ADDENDUM NO. 4

To: Invited Bidders
Project: **St. Mary Fort Walton Beach Admin Building & Renovation**
Fort Walton Beach, Florida
Date: June 24, 2026 Bid Date: June 30, 2026
Architect: Quina Grundhoefer Architects

6/15/26 ADDENDUM #4

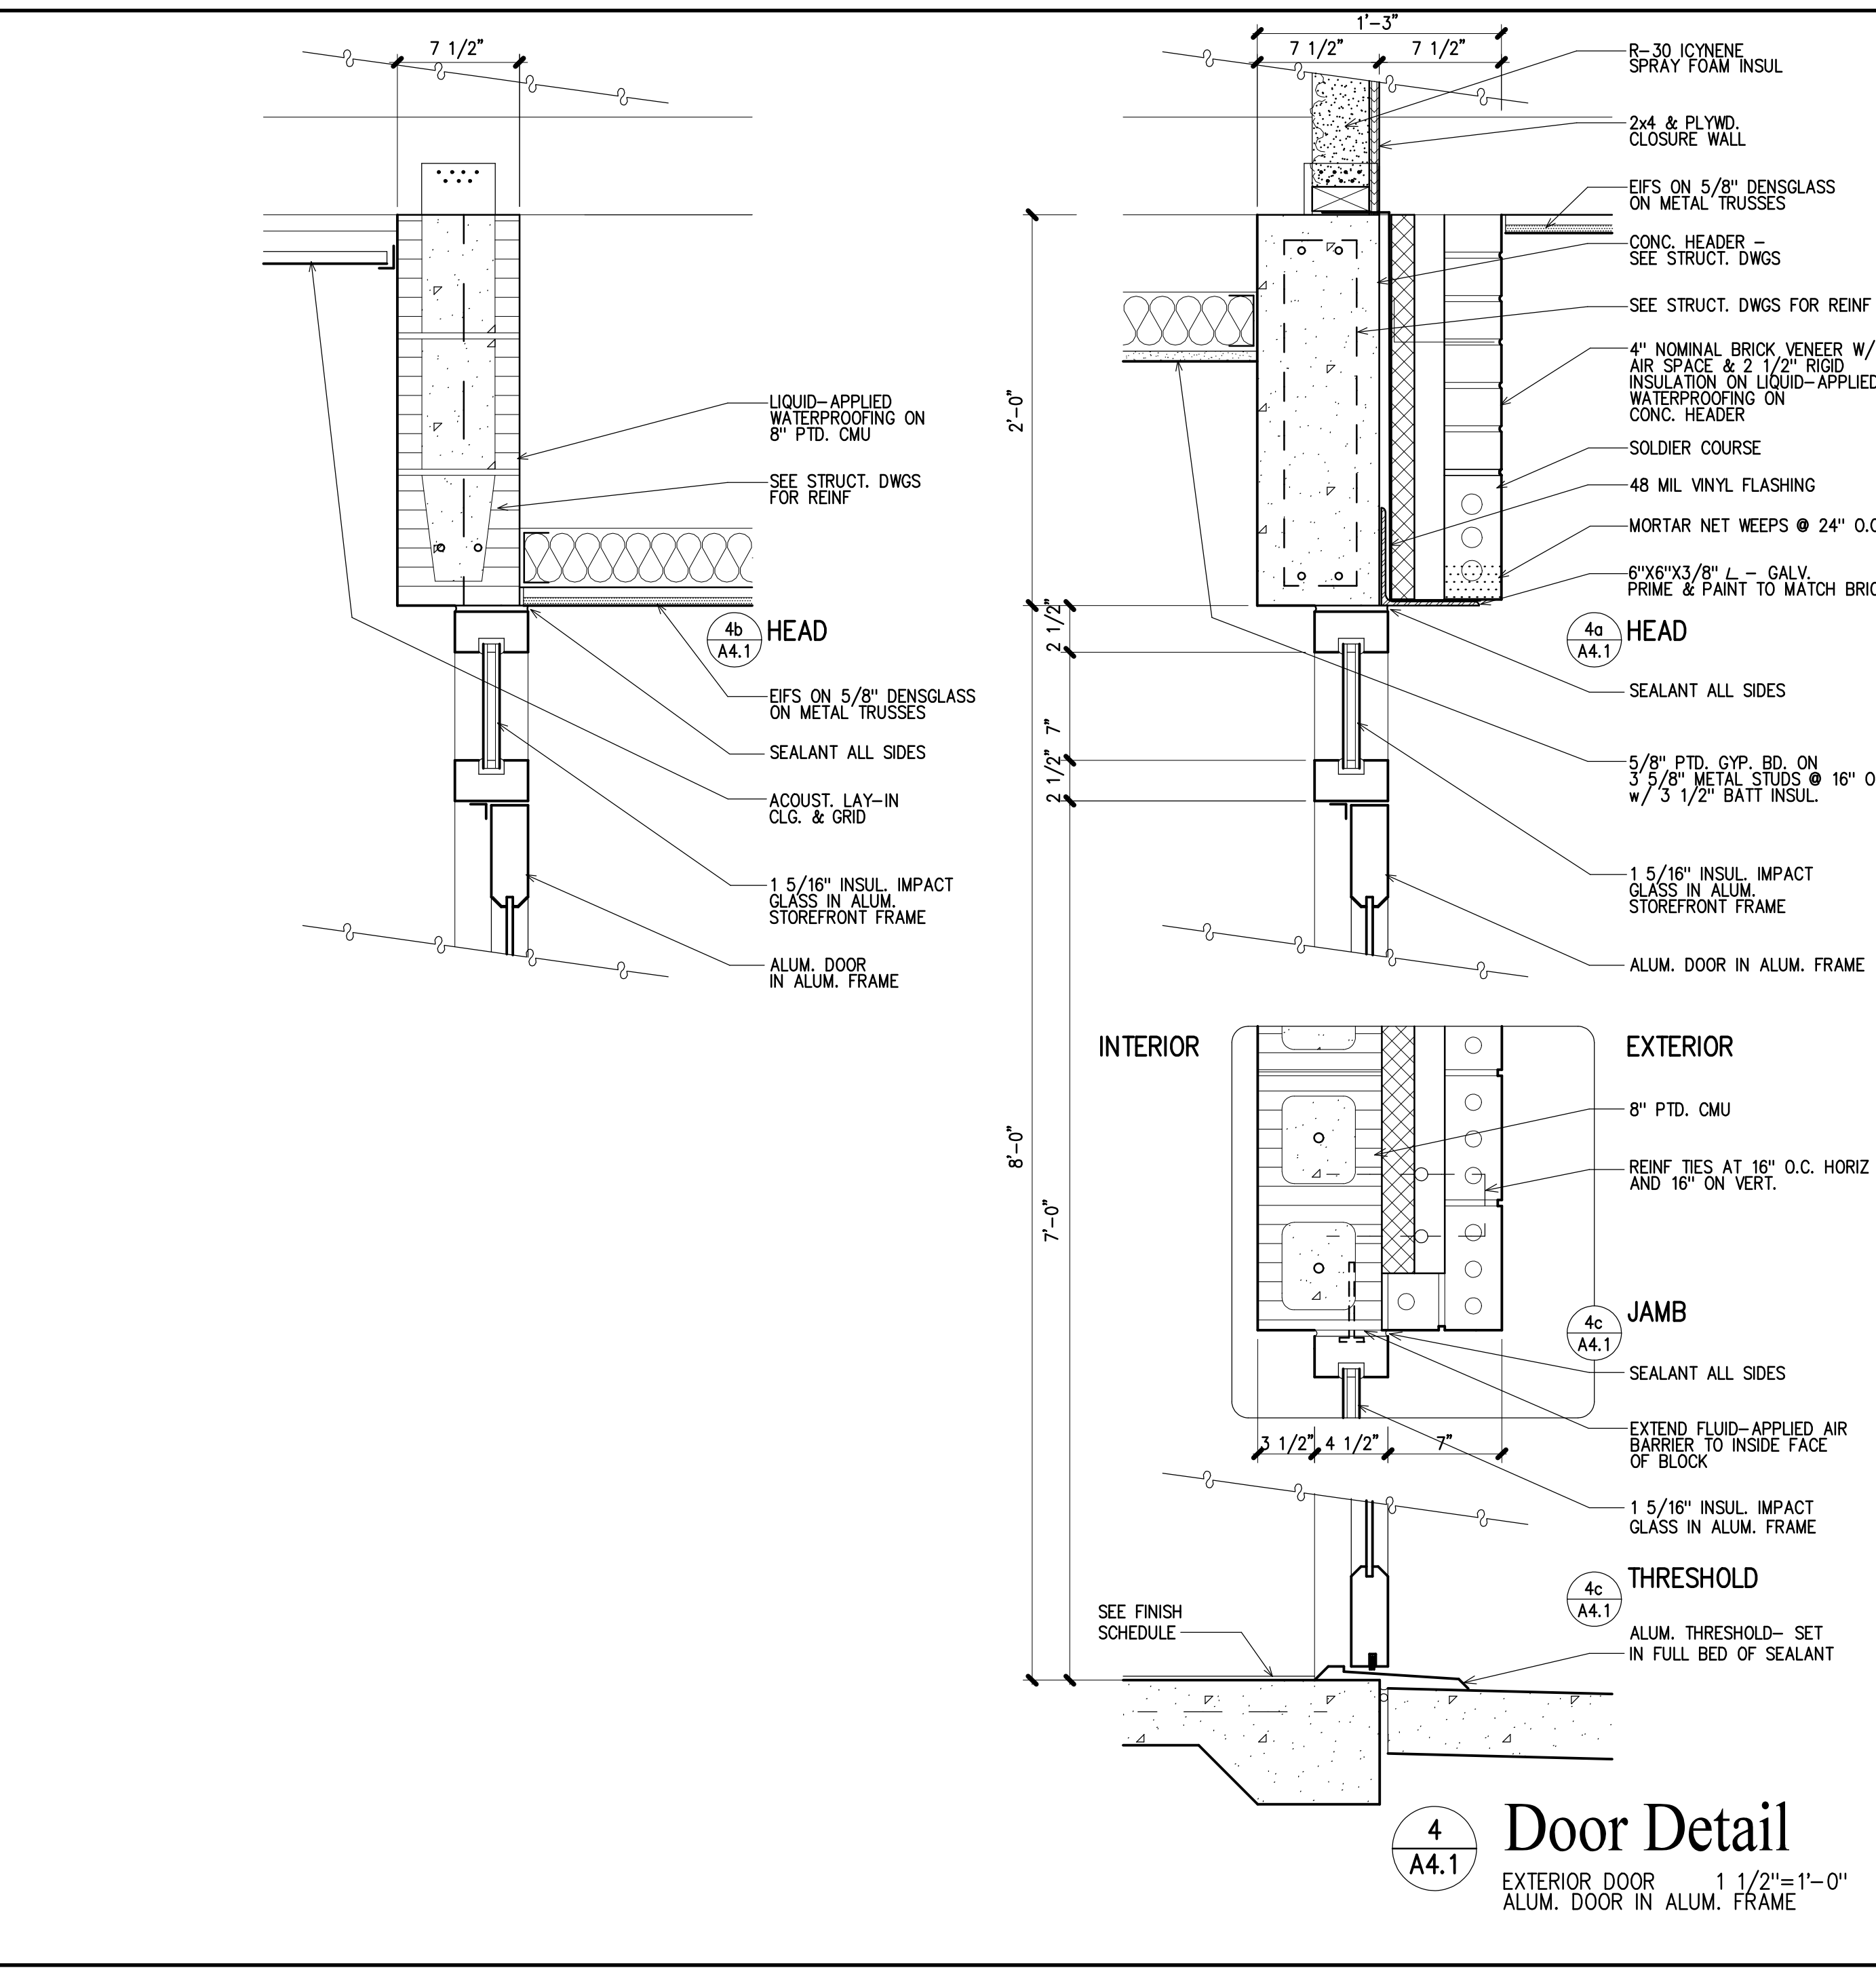
- a. Add door elevation H to sheet A4.1.
- b. Change doors 17 & 27 from elevation B to H.
